**RE: Permit Correction Response #1 – 3020114**  
 6726 Greenwood Ave N | Seattle, WA

Correction Notice #1  
 Lori L Swallow  
 May 17, 2016

**From:** Neil Buchanan [<mailto:buchanan@isomedia.com>]  
**Sent:** Friday, February 12, 2016 11:58 AM  
**To:** Ames, Bill  
**Subject:** Emailing: 6720 Greenwood Ave N L1 (2-12-2016).pdf

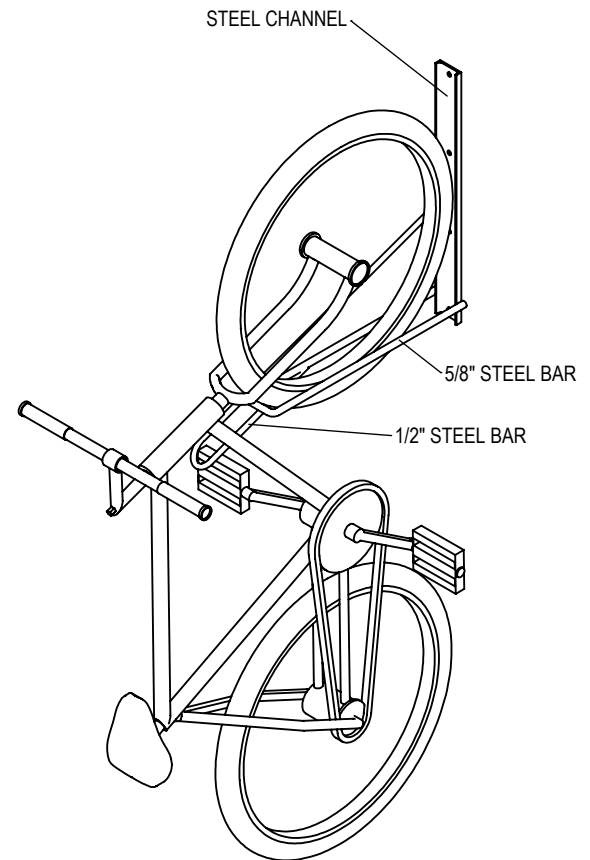
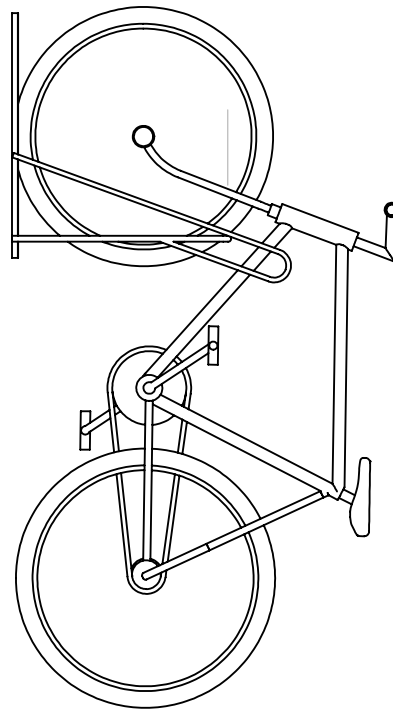
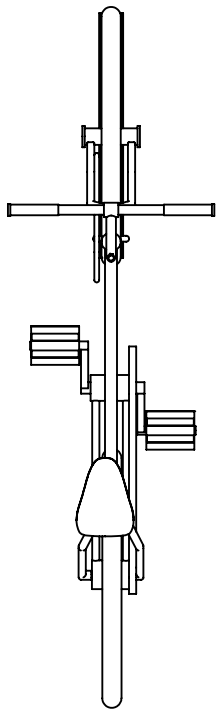
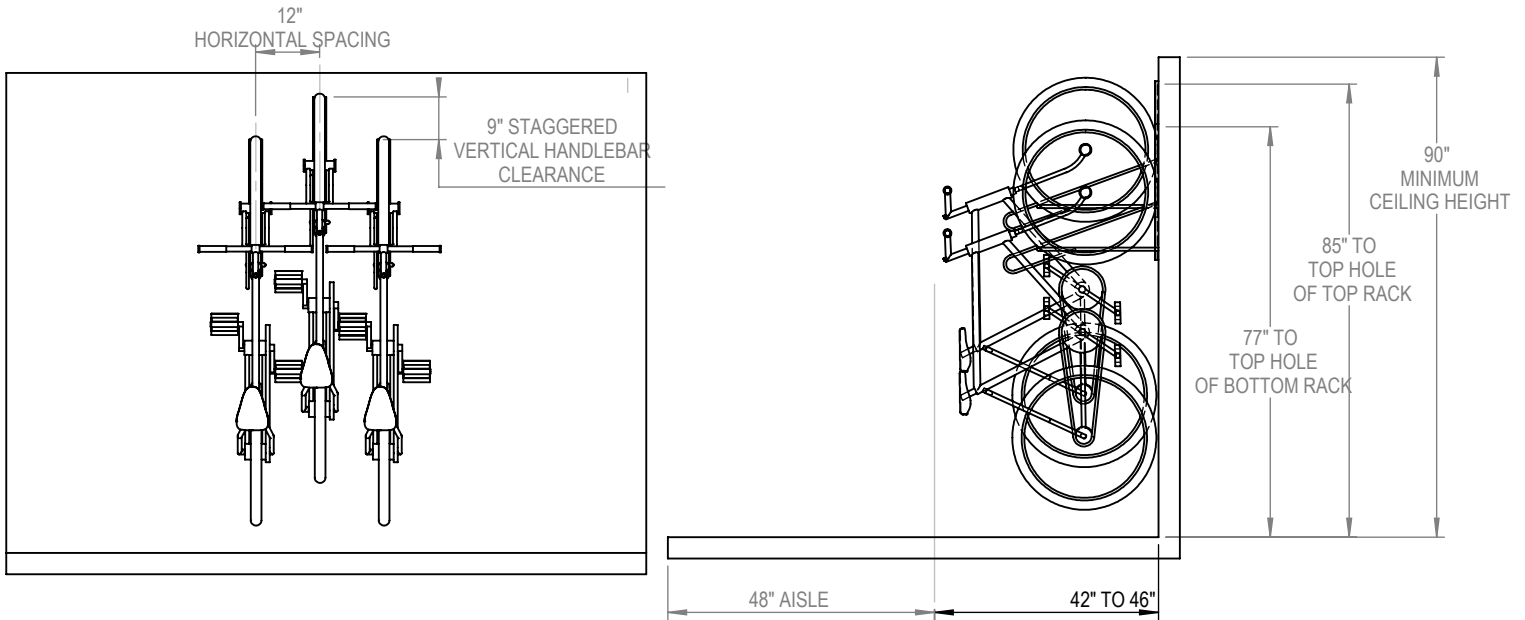
Looks like room for two new trees on N 68th St, no overhead lines. Planting strip is about 11' wide. There is a driveway just to the west of the property line and water and sewer lines so I just see room for two trees.

What variety would you like to see here?

On N 68<sup>th</sup> St call-out Bald cypress (*Taxodium disitichum*), 8-feet tall. This will be a good place for them.
